LUBBOCK COUNTY
Woodrow Road Phase 2 – SLIDE ROAD TO INDIANA AVE
ITB 250801

Addendum No. 3

**CR 2330 EASEMENT
GRADING LAYOUTS**

EROSION CONTROL
PLAN SUMMARY

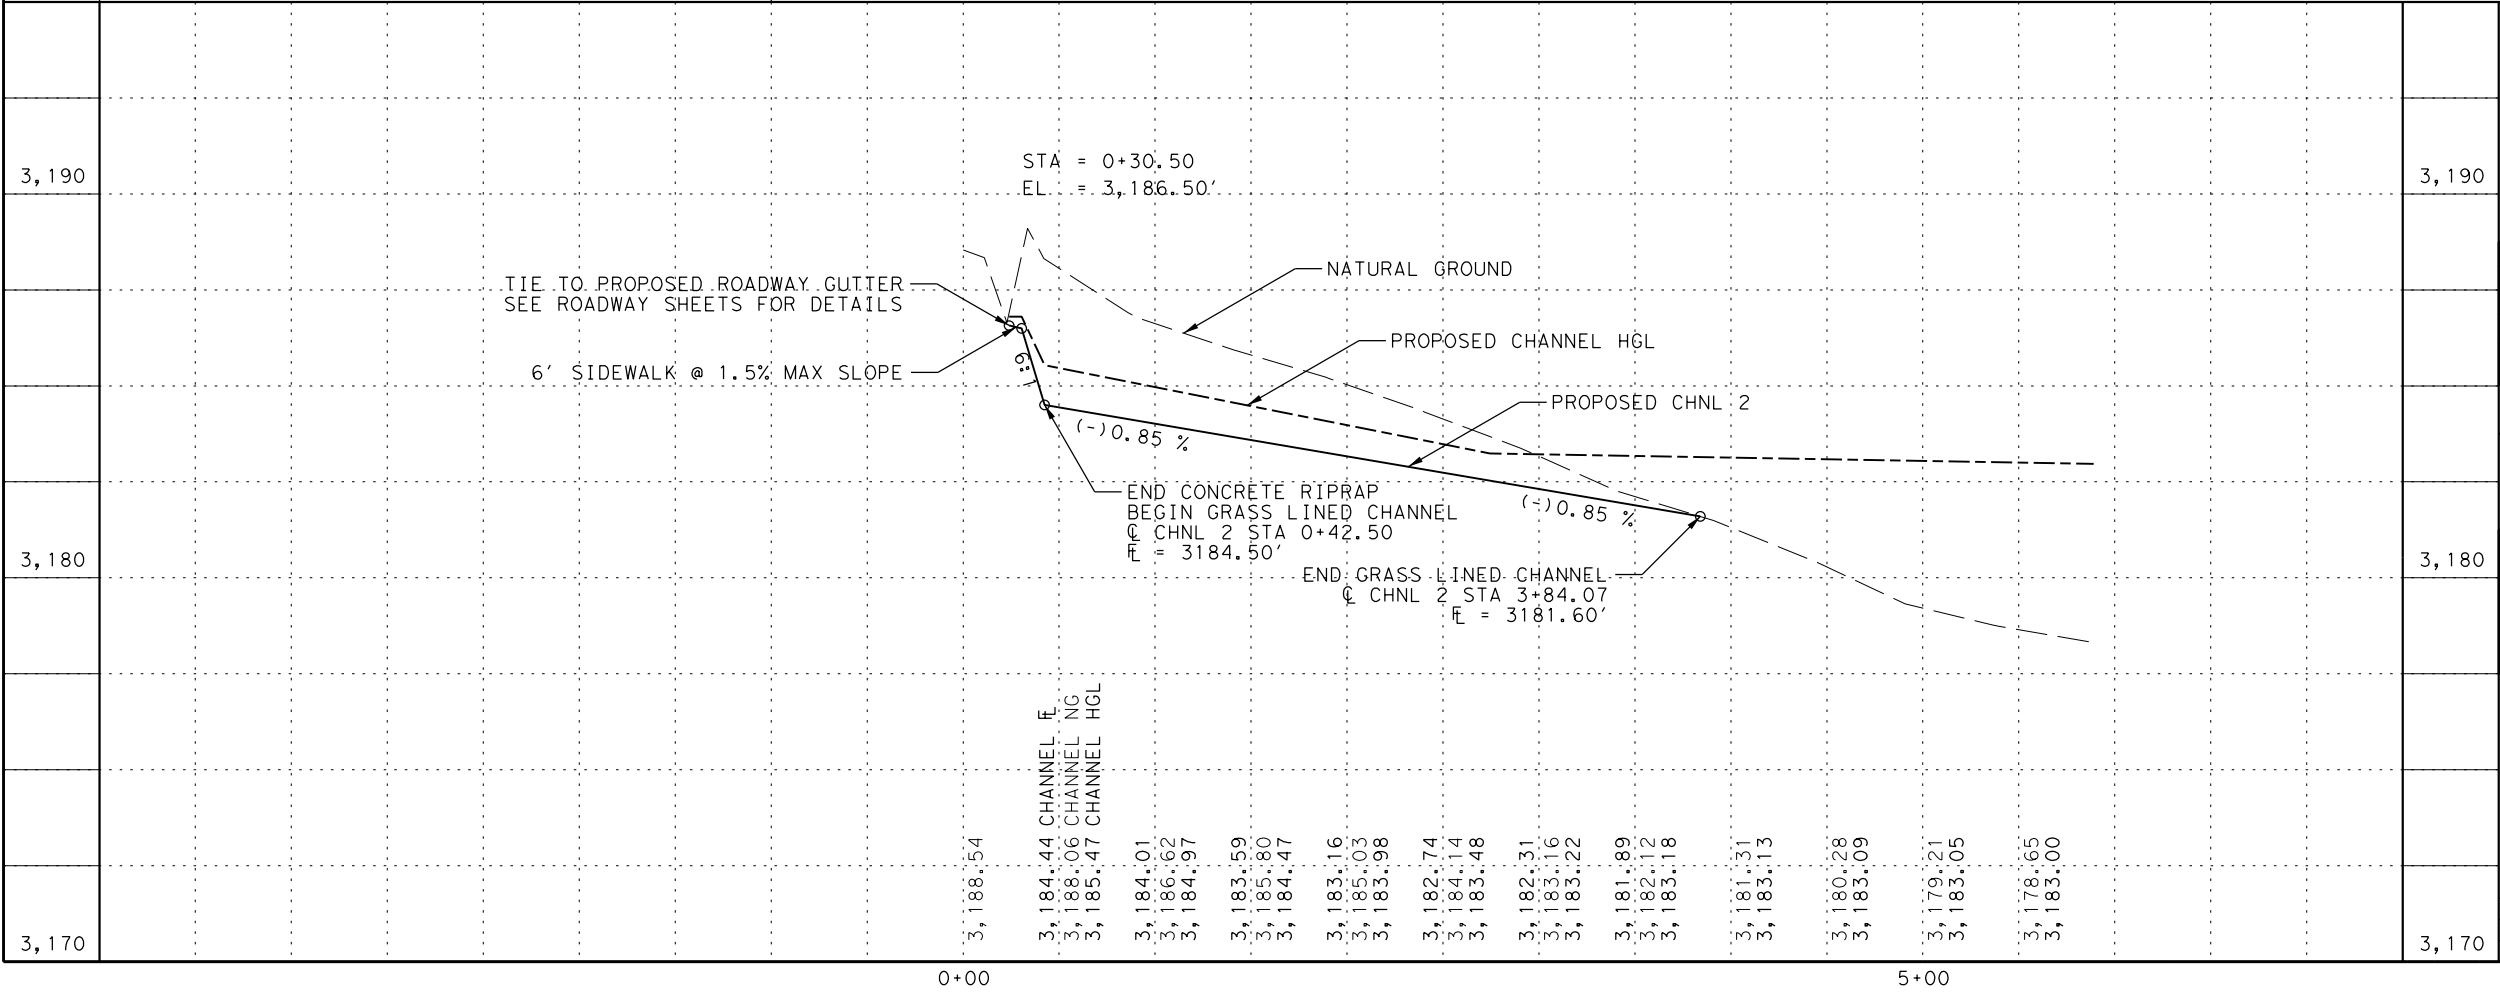
1. E&Q – SHEET 17, 17A – 17C
 - Added Item 0506 6020 – CONSTRUCTION EXITS (INSTALL)(TY 2)
2. CR 2330 EASEMENT #2 GRADING LAYOUT – SHEET 169
 - Corrected incorrect plan view elevation to match profile elevation.
3. EROSION CONTROL PLAN SUMMARY – SHEET 243
 - Added Item 0506 6020 – CONSTRUCTION EXITS (INSTALL)(TY 2)
